**CITY OF WILSONVILLE
SECOND AMENDMENT TO CONSTRUCTION CONTRACT**

5th Street/Kinsman Road Extension

**Exhibit A - Change Order #02
Pay Item Adjustment**

Exhibit B – Change Order #02 Pay Item Detailed Description

5 PGE/COMM CASING SECTION
6.3 1" = 10'

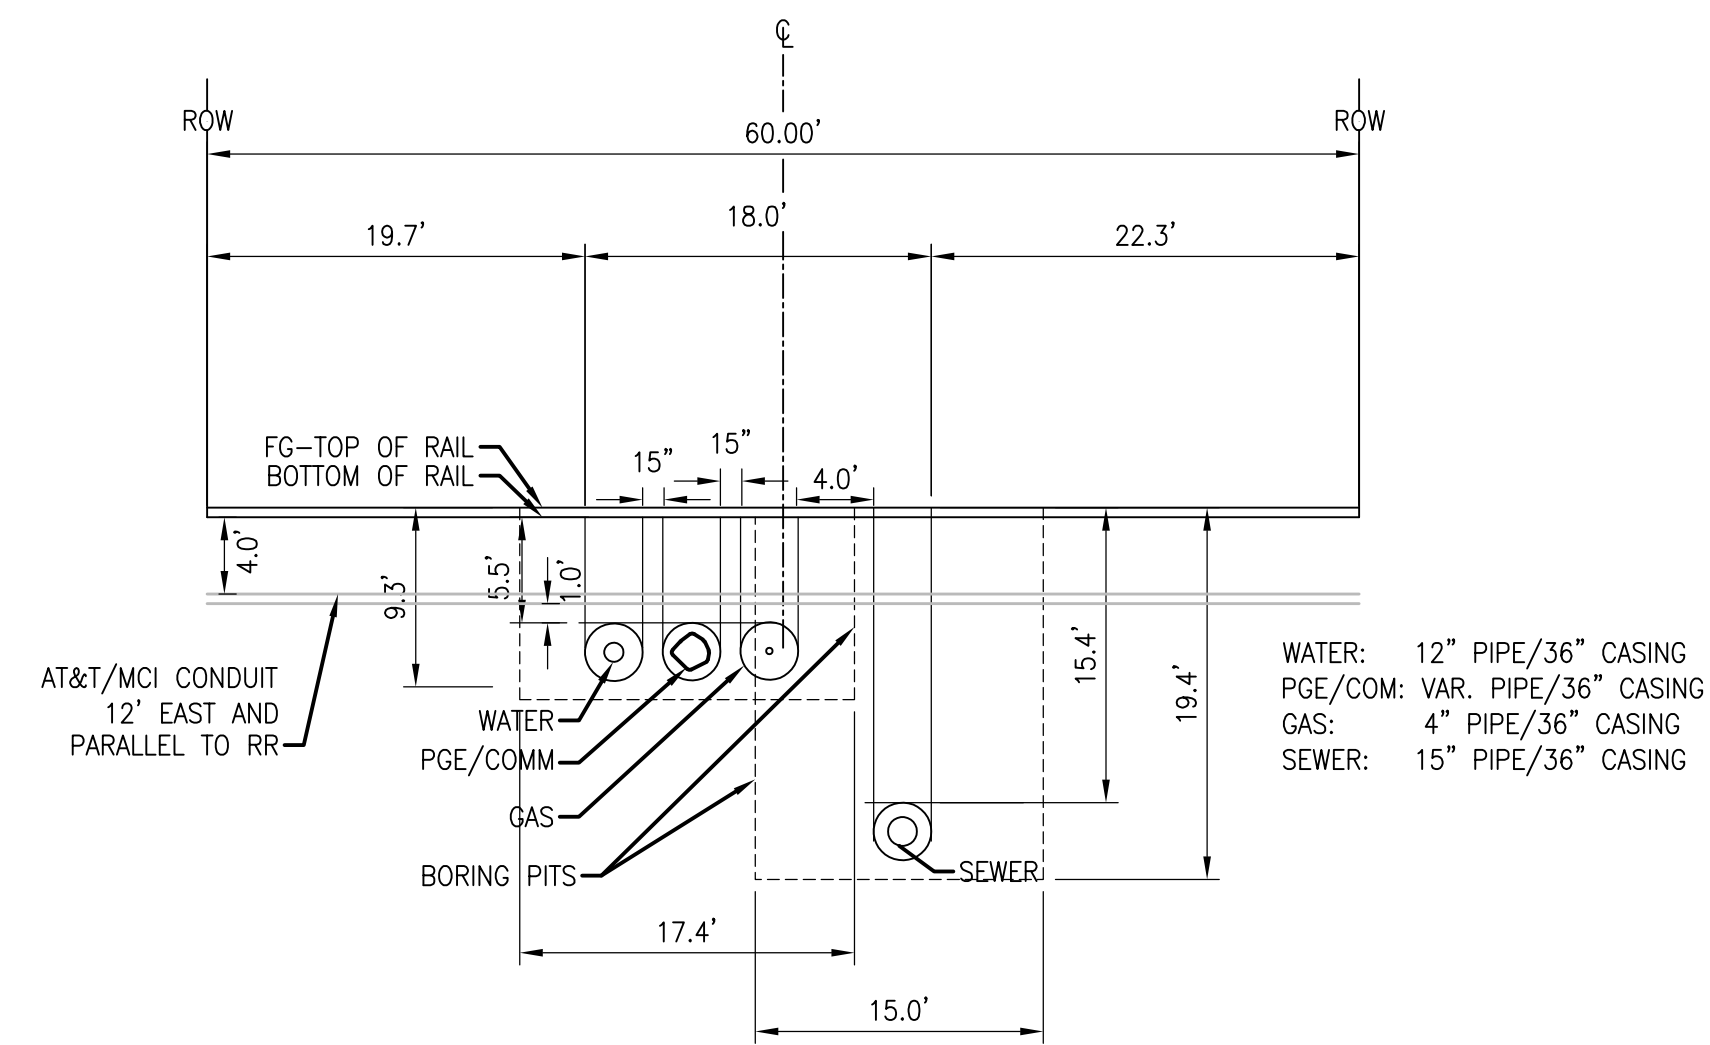
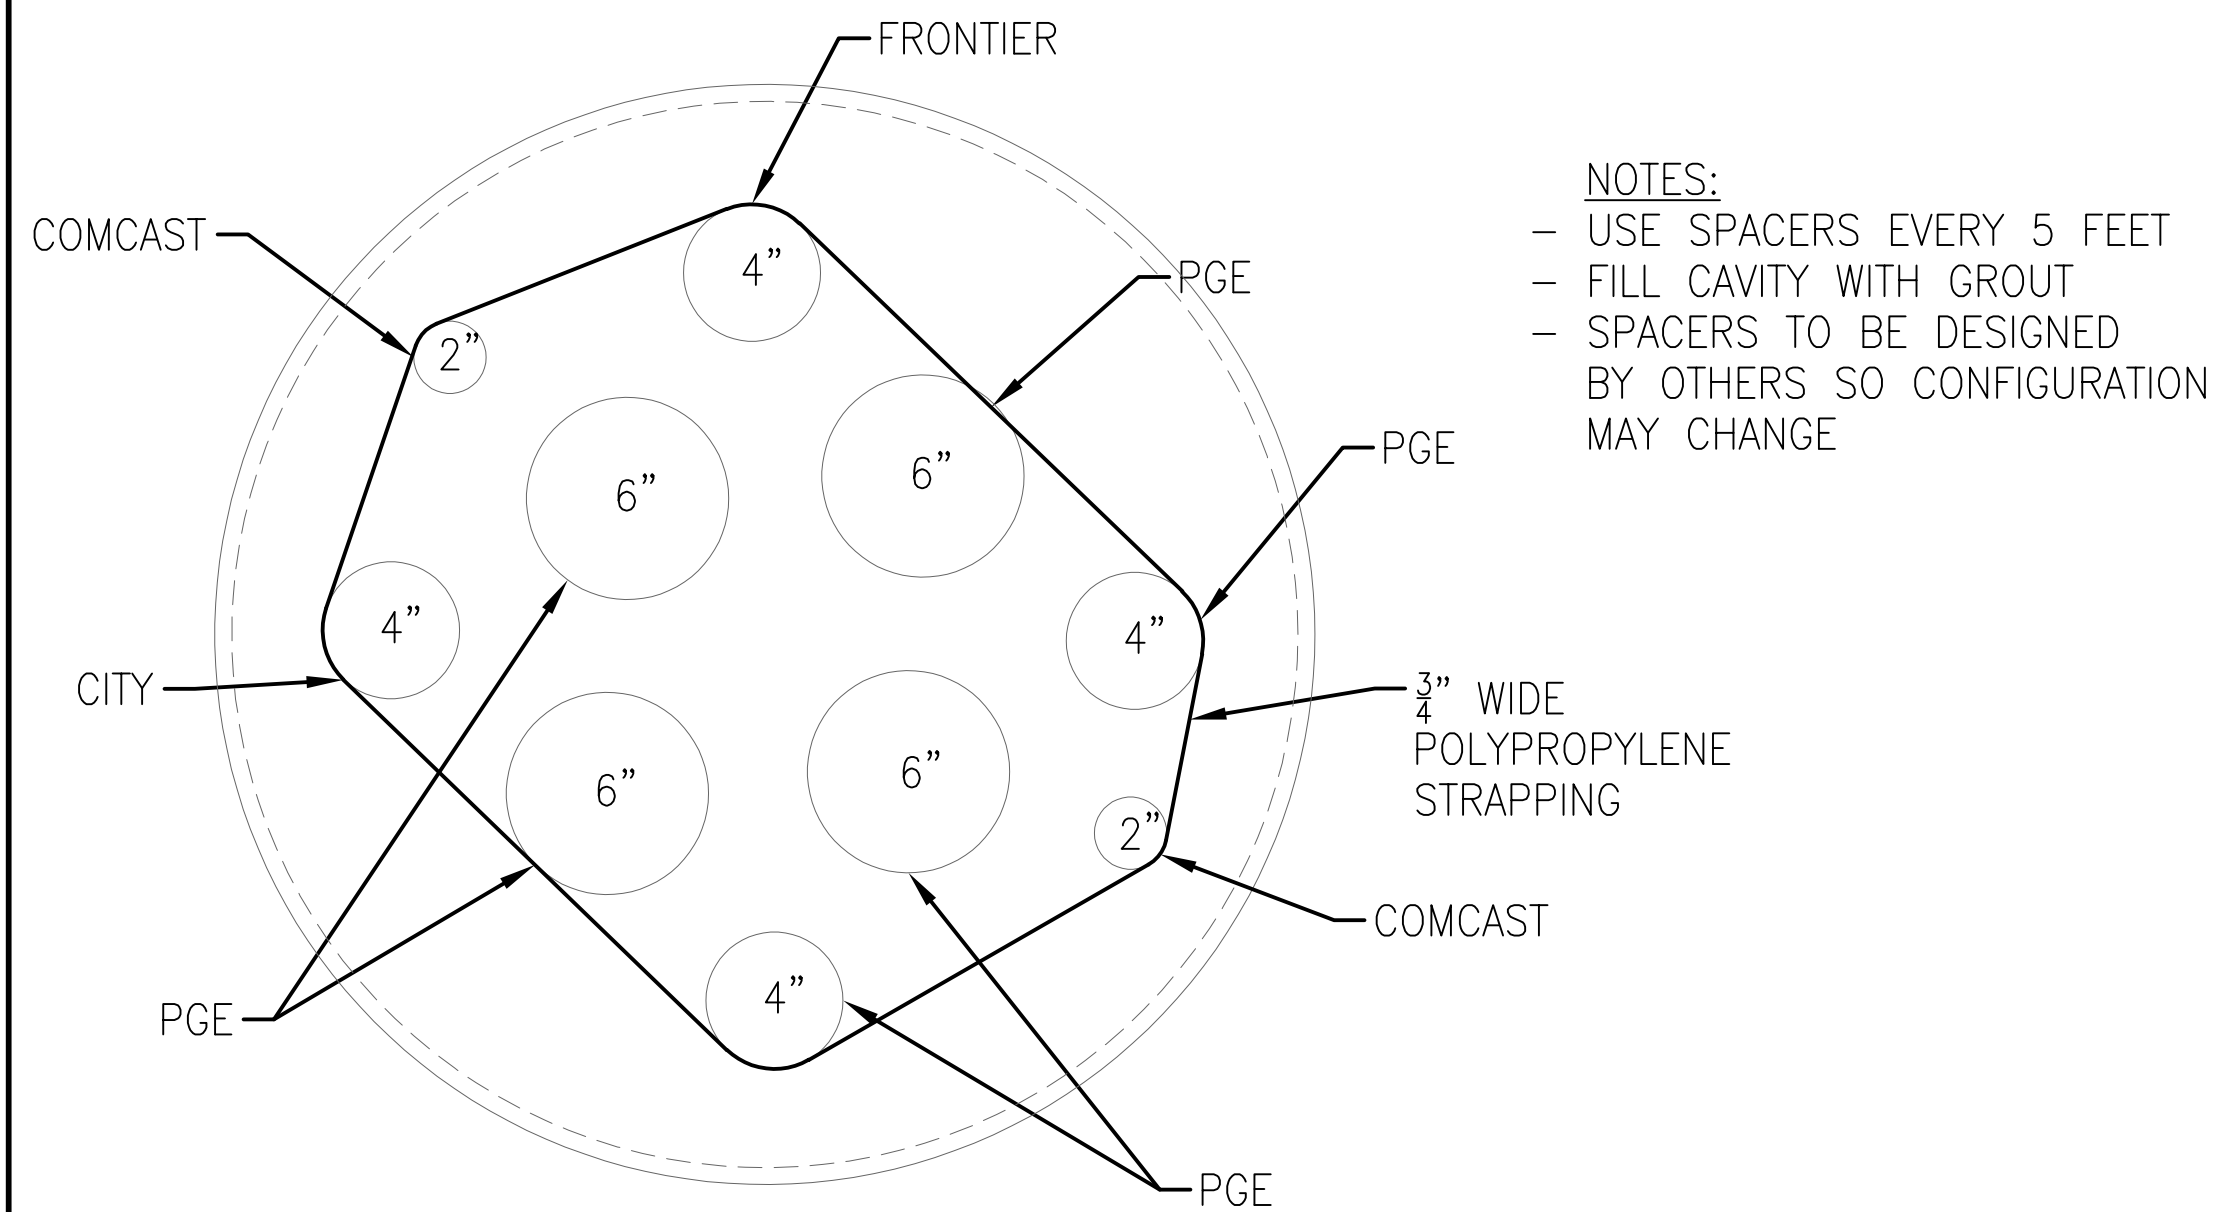
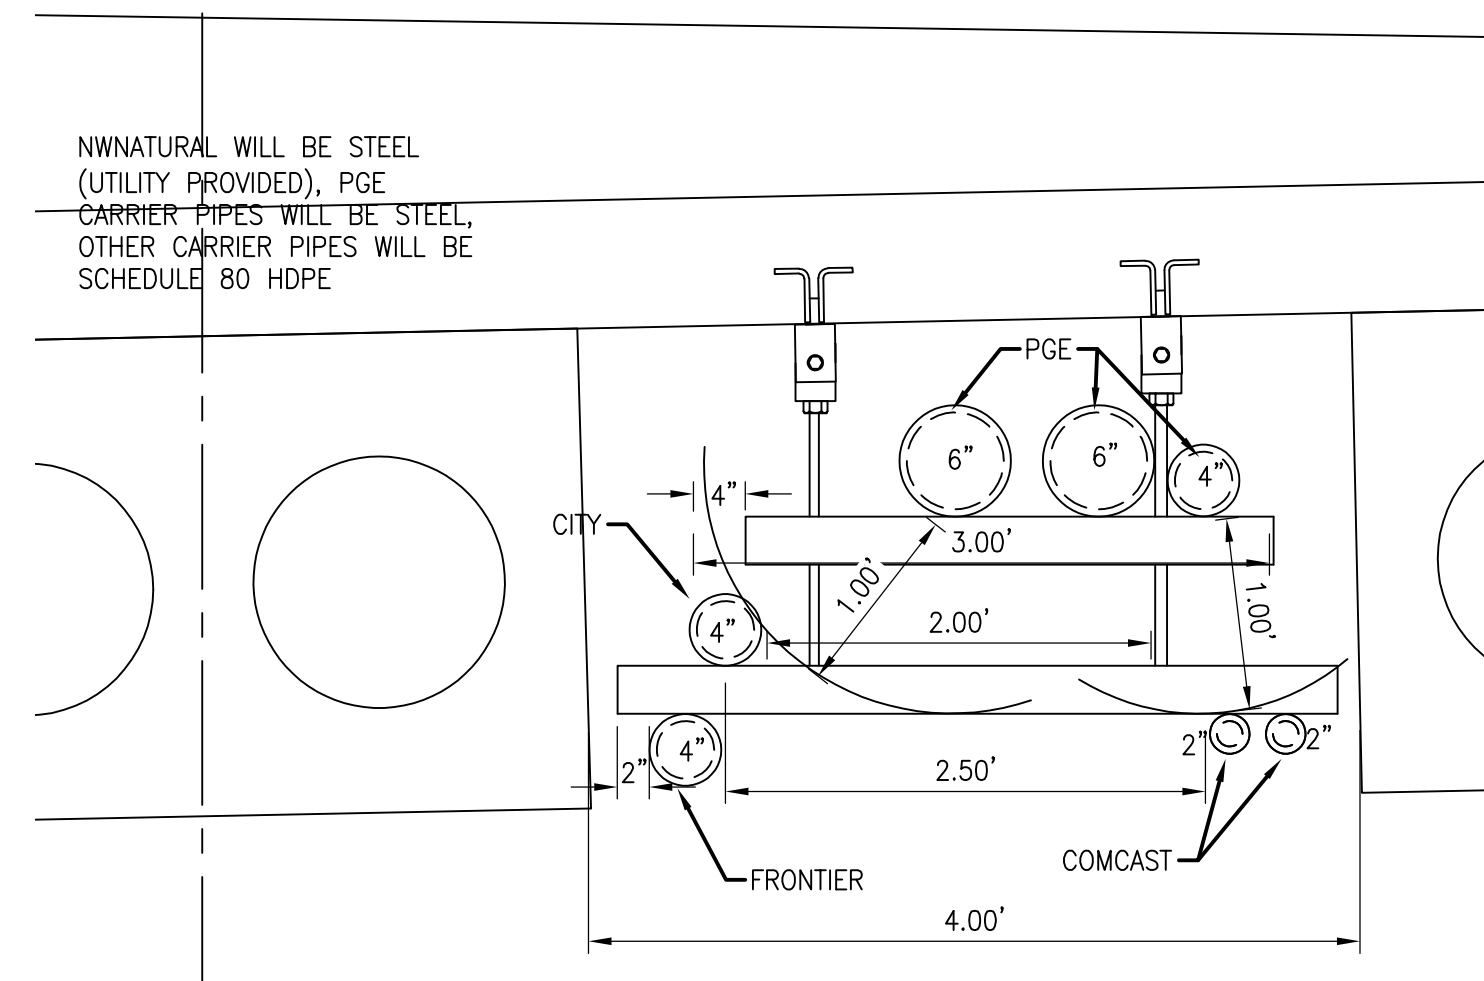
During bore installation of the 6” diameter casing pipe for the natural gas pipeline crossing beneath the railroad tracks, the Contractor was unable to complete the work after a number of attempts due to the presence of boulders. The Contractor determined that the small size of the casing pipe does not provide enough room to access and remove the conflicting portions of boulders. The Contractor proposes an upsized 36” diameter casing pipe to provide the needed space to remove conflicting boulders and complete installation of the needed casing pipe. In addition, the Contractor mistakenly installed a larger, 36” casing for the City water pipeline, rather than the 18” casing called for in the construction documents. The utility casing pipe design changes for the railroad crossing are included on pages 23-24 of Exhibit C.

Item	Description	Qty	Unit	Unit Price	Extension
Description of Change(s)					
Boulders were encountered while installing the 6" gas casing at the design depth of 7' ; This was not called out in the plans or geotech report and is a differing site condition; this COR reflects the standby time as a result, and the costs to upsize the casing to alleviate the boulder issue.					
Pricing					
Reject	Standby time	1.00	LS	\$ 17,118.04	\$ 17,118.04
Reject	Additional Work Upsize 6" Gas Casing to 36"	1.00	LS	\$ 17,824.20	\$ 17,824.20
Approve	CREDIT BI 55 6" Casing 7 FT Depth	1.00	LS	\$ (40,000.00)	\$ (40,000.00)
Approve	BI 57 36" Casing 7 FT Depth	1.00	LS	\$ 80,000.00	\$ 80,000.00
Reject	Bore Sub Additional DeMob and Mob	1.00	LS	\$ 12,800.00	\$ 12,800.00
Approve	City Share Gas Casing Relocation Work				\$20,000.00
	TOTAL				\$ 60,000.00
Terms, Conditions, and Scope Limits/Clarifications					
Additional contract days will be requested starting from the beginning of the delay on 10/18/2021 to the end of the delay when pricing is approved

Note: The City does not agree that the obstructions encountered constitute a differing site condition, but agrees to pay a portion of added work to install a larger casing for the gas line.

1. RR Crossing unforeseen change request. The City will accept the last settlement offer of paying the difference between the 6" casing and the 36" casing for the Gas casing (\$40,000) as well as paying 0.5 of the 6" bid item for all other extra work claimed (\$20,000).
2. Water Quality Curb reinforcing credit. The City will accept the last credit amount of \$7,000.00.

CHAIN LINK FENCE AND GATE

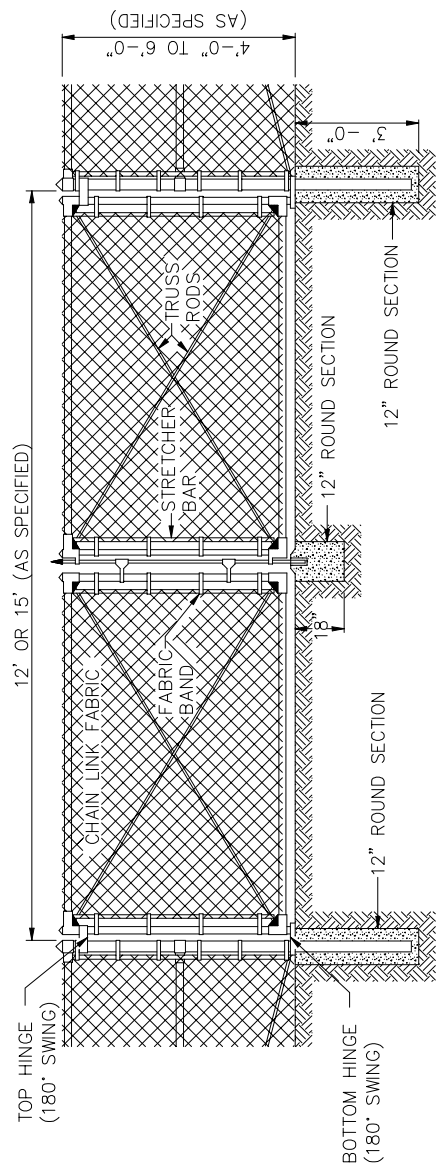
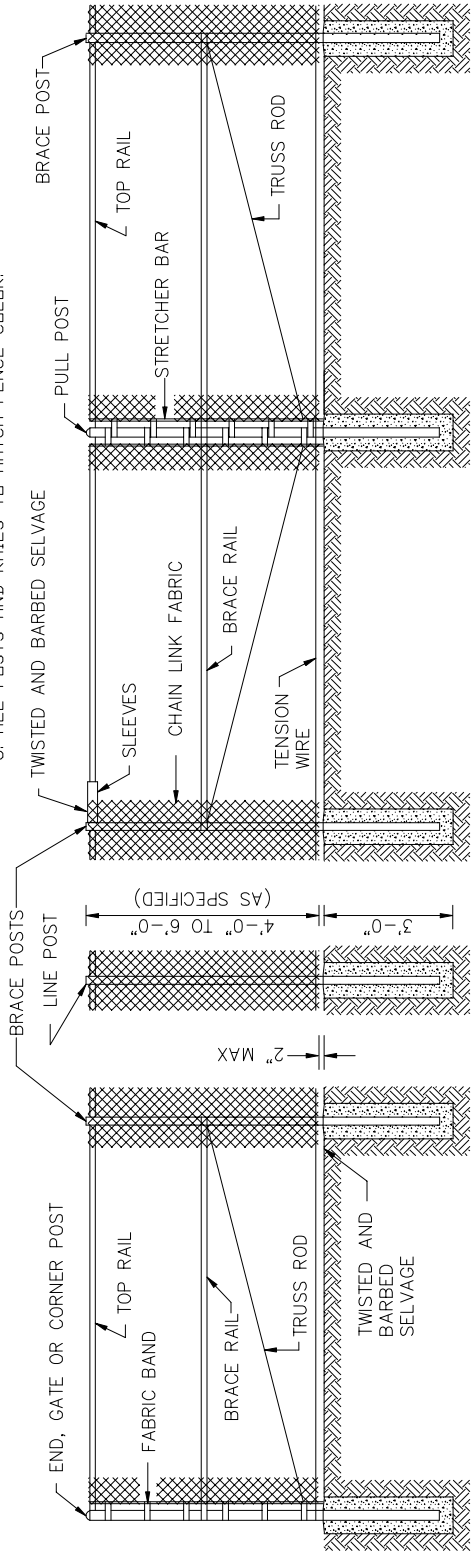
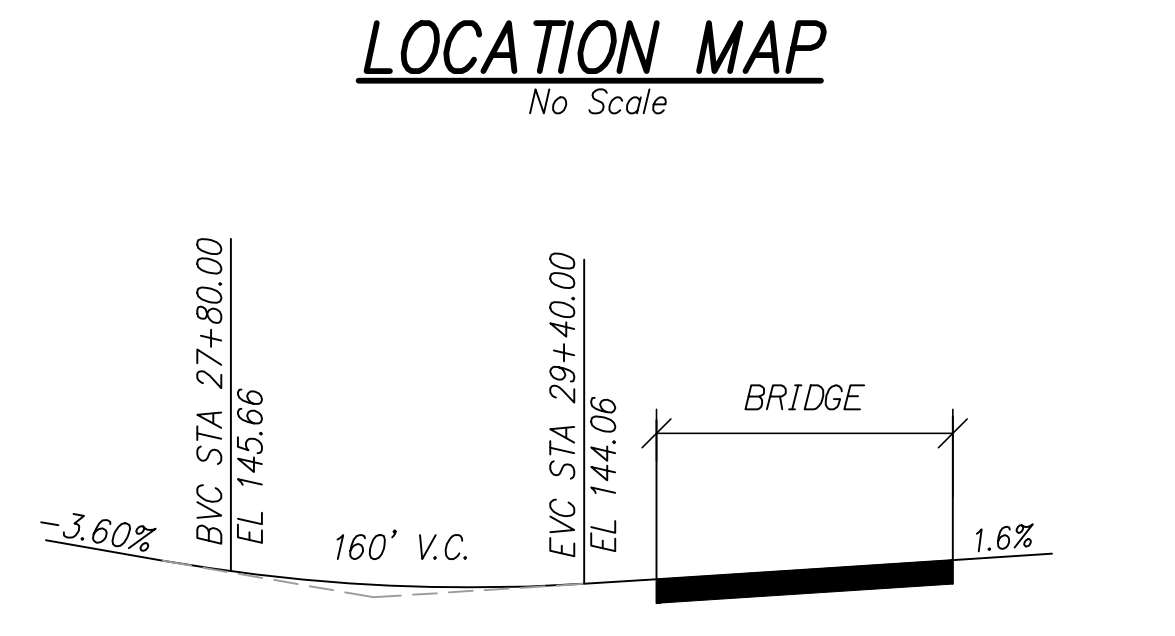
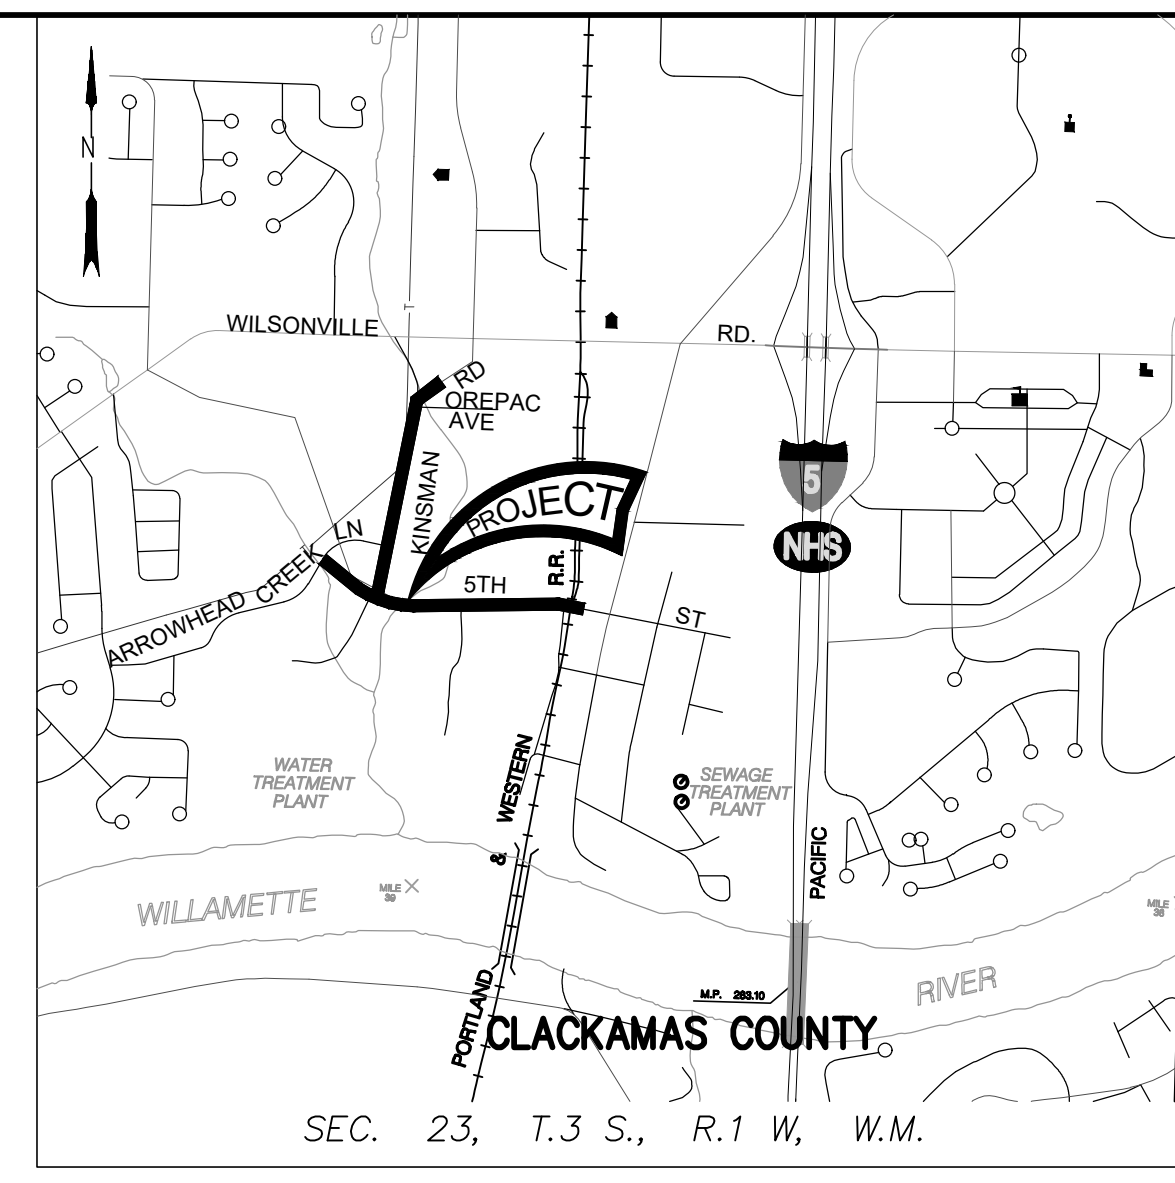
Sheet PP-03 Note 25 calls for a 31" height guard rail.

The city would like to add chain link fence. Please provide a proposal for installing 4-foot high black chain link fence (CWS standard detail No. 792) for each bridge. The fence locations would be from the corner for the bridge railing along the back side of the wing walls at all four corners. Please follow OSHA standards and requirements. The tops of the poles should be situated as best as possible below the decorative bridge deck railing. Confirm field location and fit with city inspector prior to placing.
